Orica Chlor-Alkali Plant-Mod-7 Gas-fired boiler

State Significant Development Modification Assessment Report (DA35/98-Mod-7)

July 2026

Figure 4 | Modified Site Layout

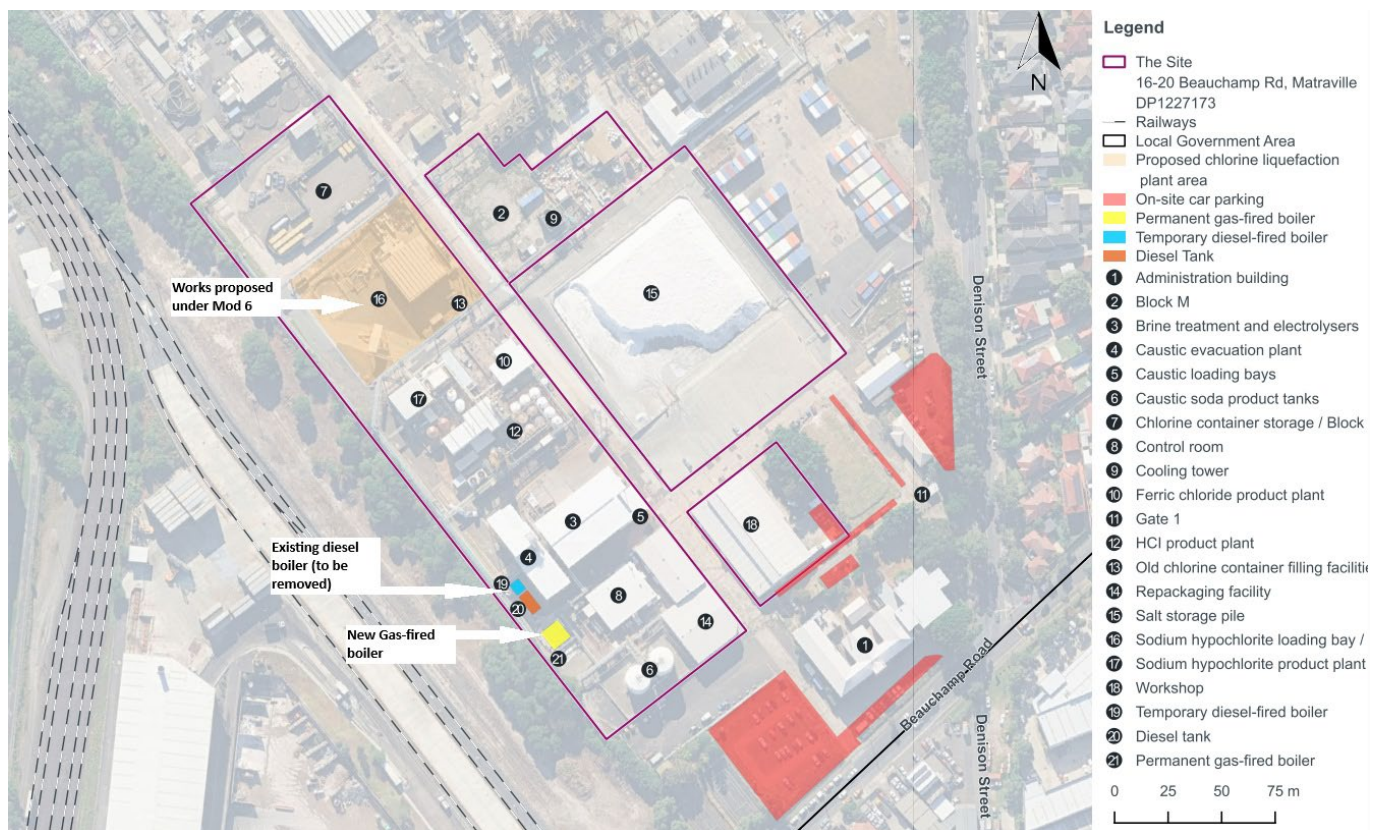
The modification seeks to permit the construction and operation of a 6 MW natural gas-fired water-tube boiler, including a semi-enclosed roofed boiler house, ancillary equipment and extension to existing pipework to ensure a reliable long term steam supply.

The modification also includes a temporary increase in vehicle movements during construction. This increase will be limited to:

- Light vehicles: 3-4 additional per day
- Heavy Vehicles: 1-2 additional per day
